MARION TOWNSHIP  
BOARD OF TRUSTEES  
REGULAR MEETING  
Thursday, February 11, 2021  
7:30 p.m.

**RE: 1388 Lucy Road  
 Preliminary Site Plan Review**

### Preliminary Site Plan Review For Marion Township, Michigan

**Marion Township Zoning Map**

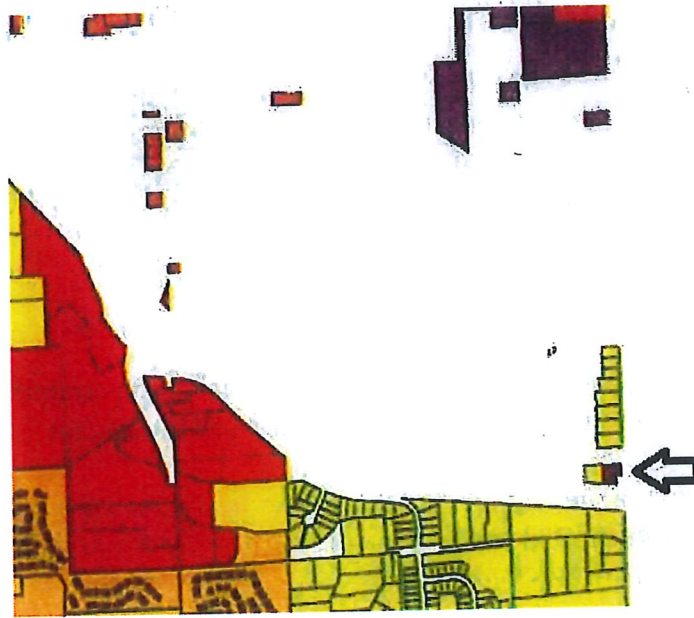
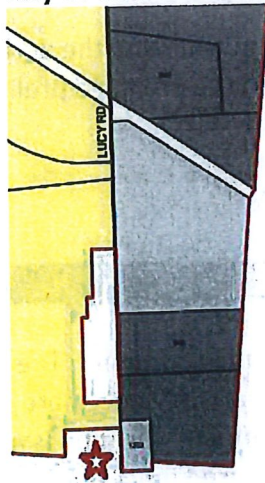
*Items to be addressed: None.*

**RETENTION BASIN PLAN & PROFILE**

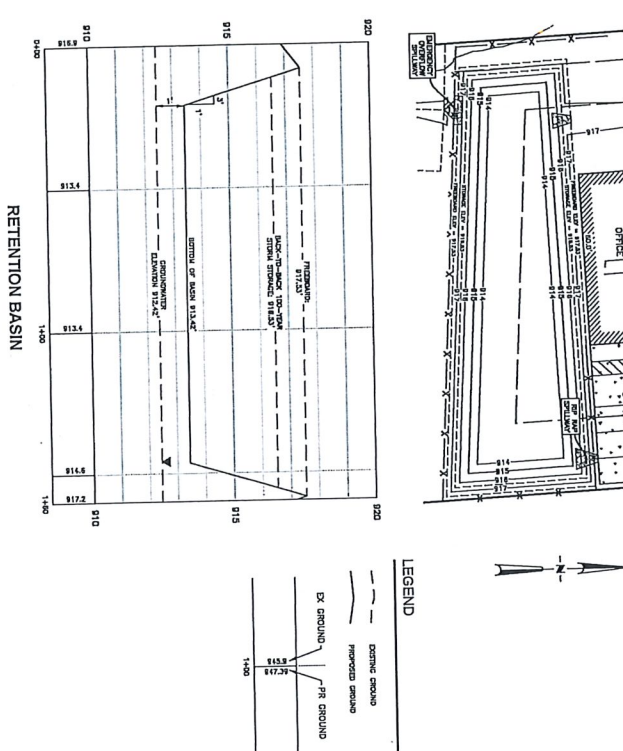
4. Details for rip-rap, and / or geo-fabric.
5. Details for 36" silt fence, straw bales, diversion berms, etc.
6. Detail of the forebay spillway
7. Detail of the emergency spillway.

8. Detail of the tracking mat.
9. The emergency spillway is located in the forebay as opposed to the main basin. This will have to be approved during Storm Water Drainage review.

Plans have been resubmitted with one comment concerning the orientation of the emergency spillway from the retention basin. MEGA is waiting on further direction from LCDDC.

# LEFT TURN PASSING LANE WARRANT

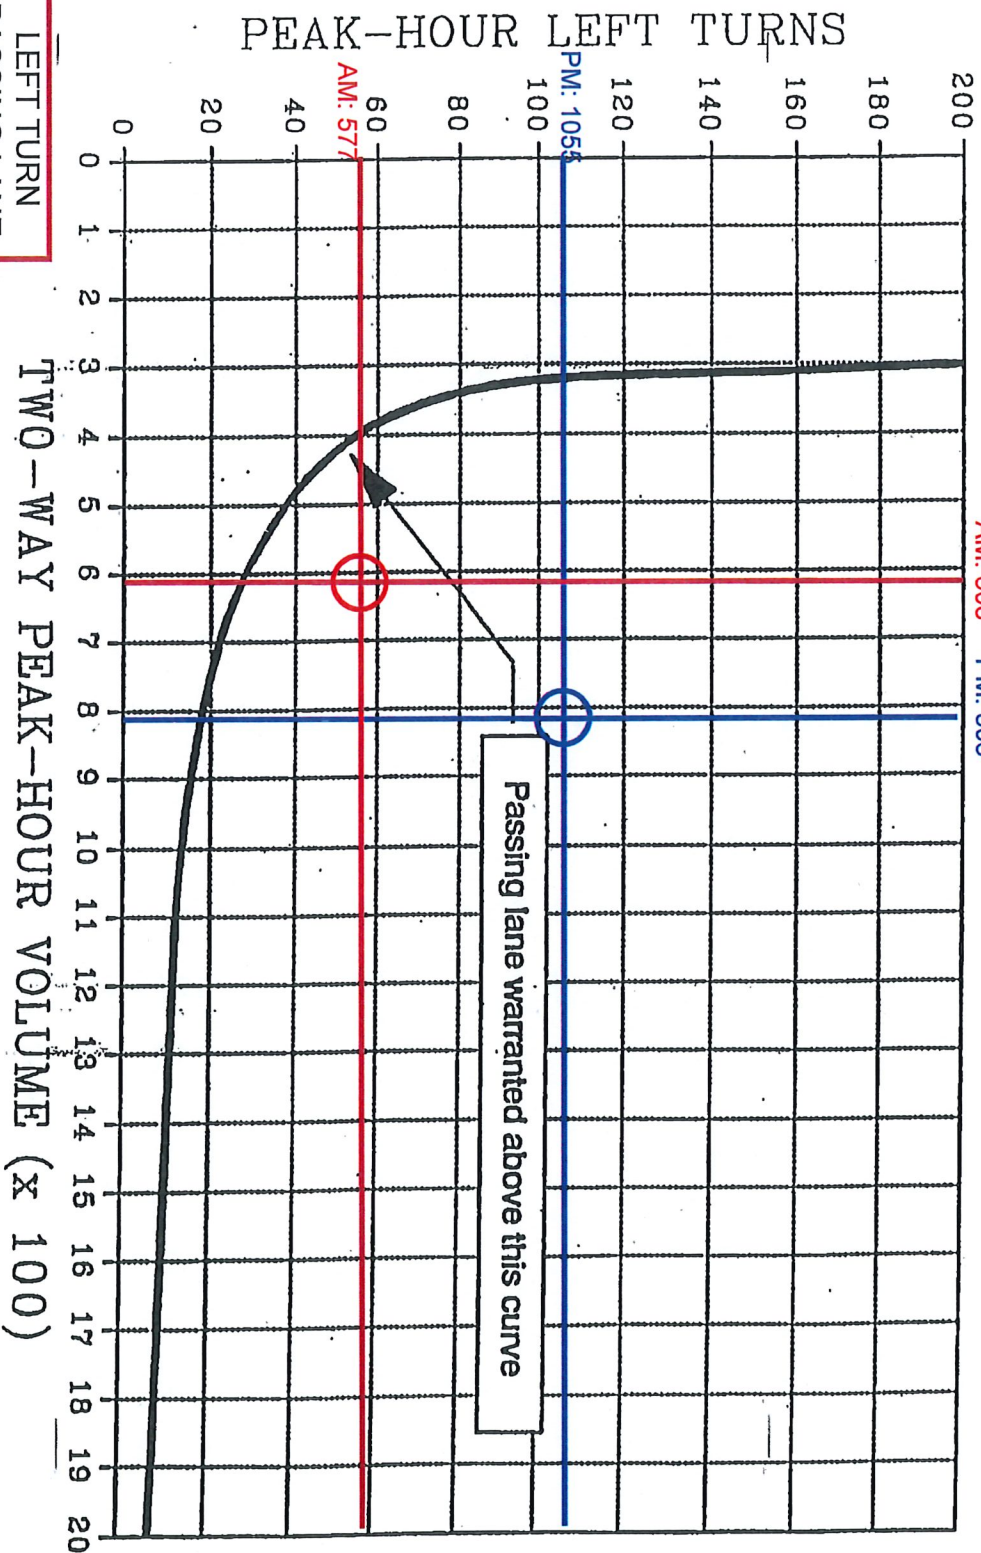
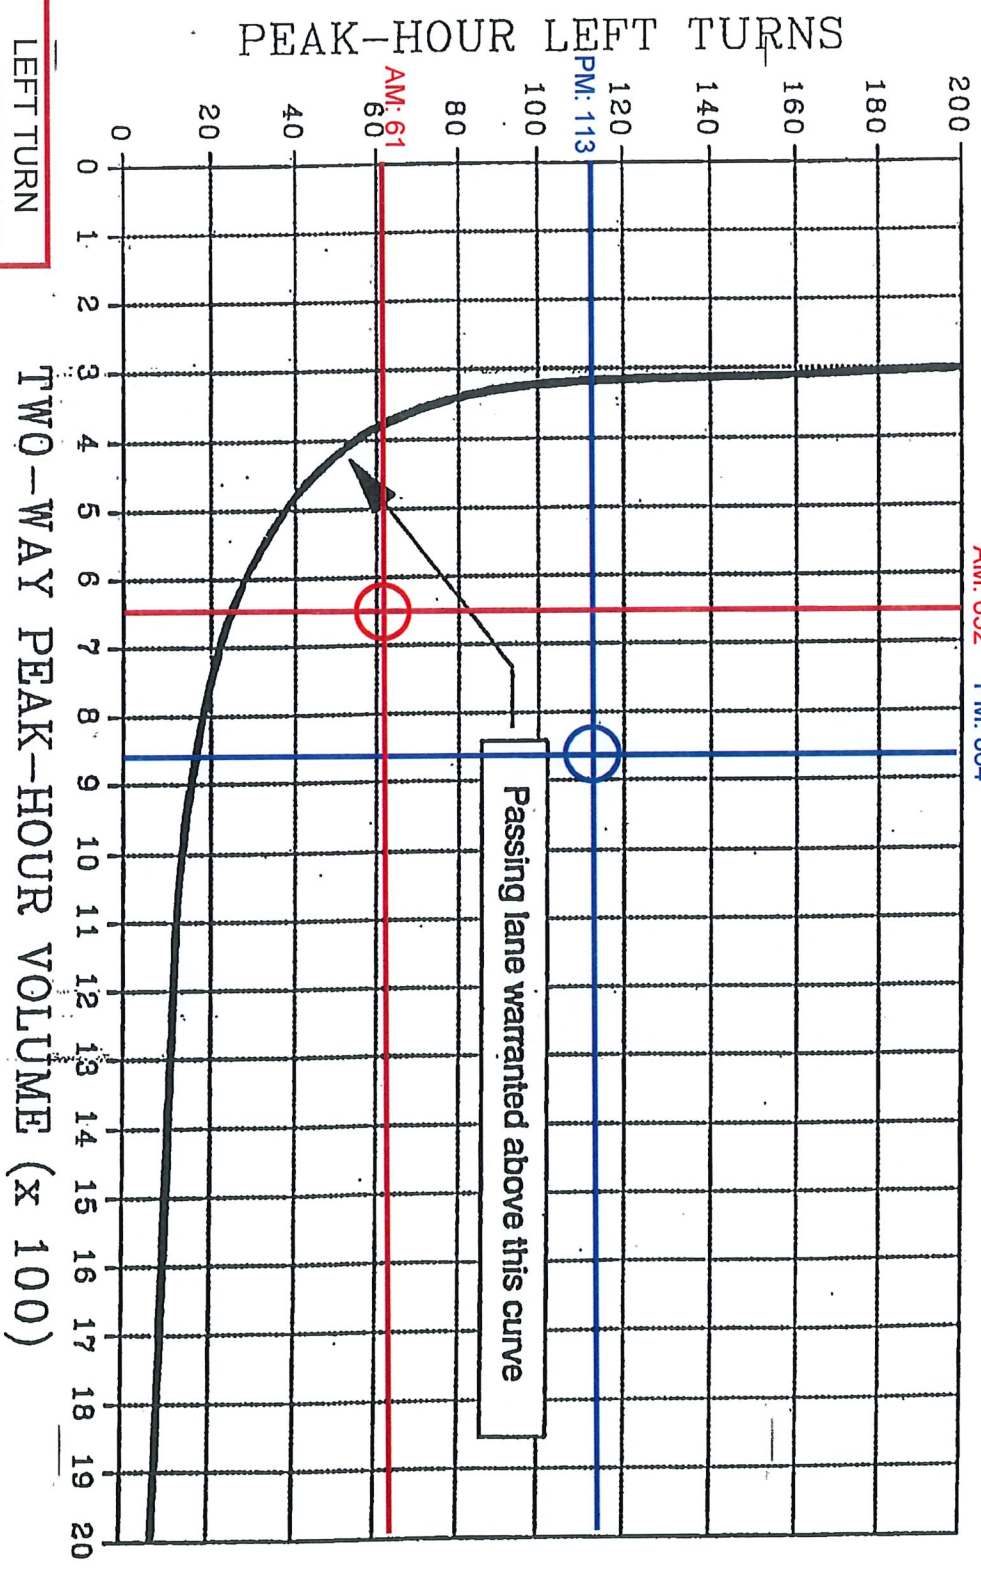
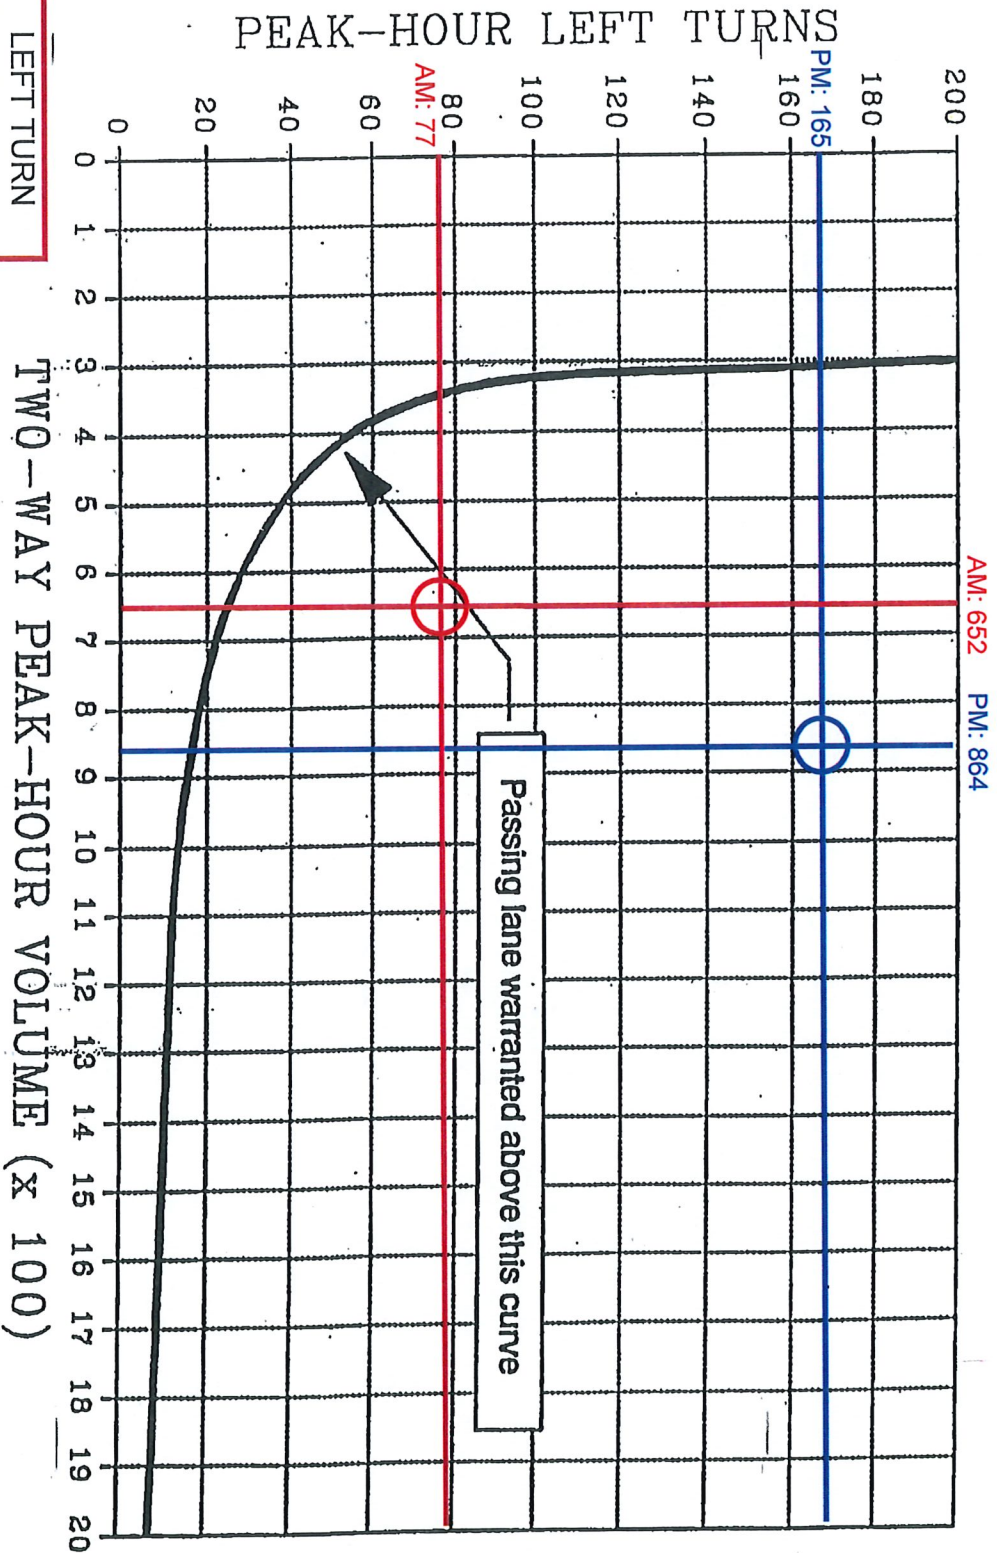
Hi Mike – the 3 attached pages are from the end of the study prepared by Fleis & Vandenbrink. As I interpret the graphs it looks like there is currently a warrant for a left turn passing lane. As I compare the current to the future conditions, it looks like the increase between the two graphs is sufficient to warrant a left turn passing lane even without the current conditions.

Am I interpreting this correctly?

TAMARACK PLACE  
GRADING PLAN SE

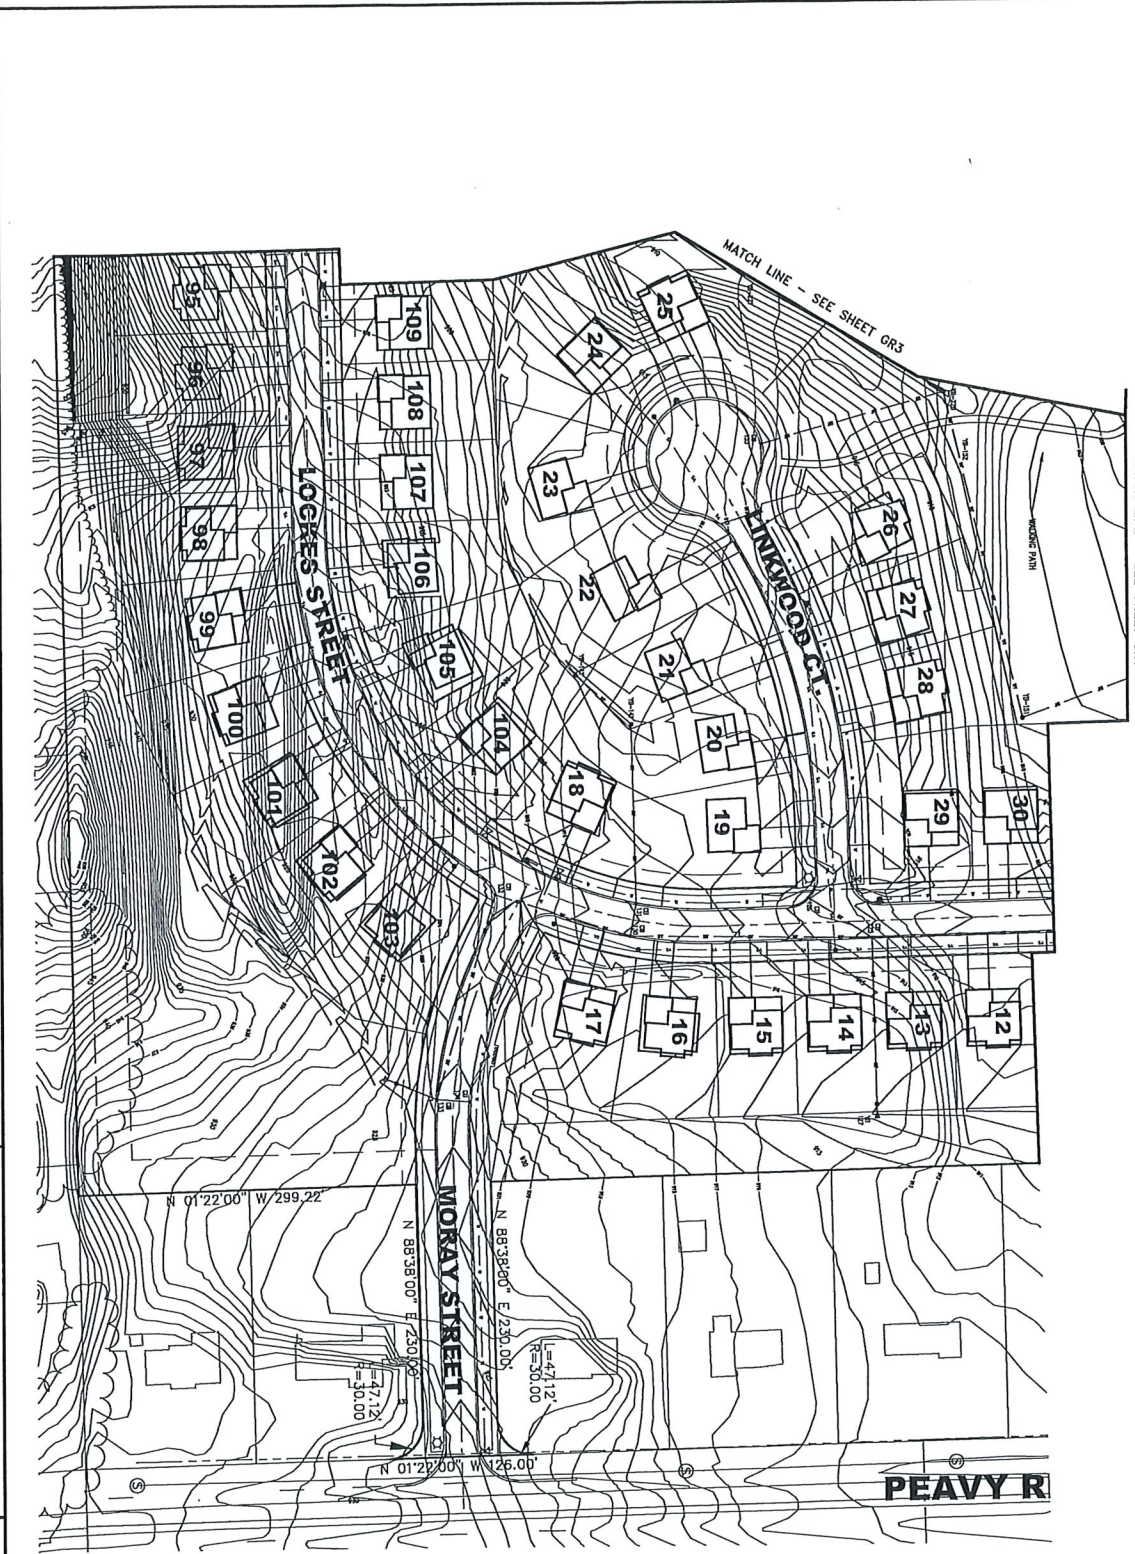
Grading Plans were submitted within the Preliminary Site Plan, but they needed some clarifications. For example, GR2.1 near the bottom of the page shows contour elevations that do not correspond to the correct contour lines.
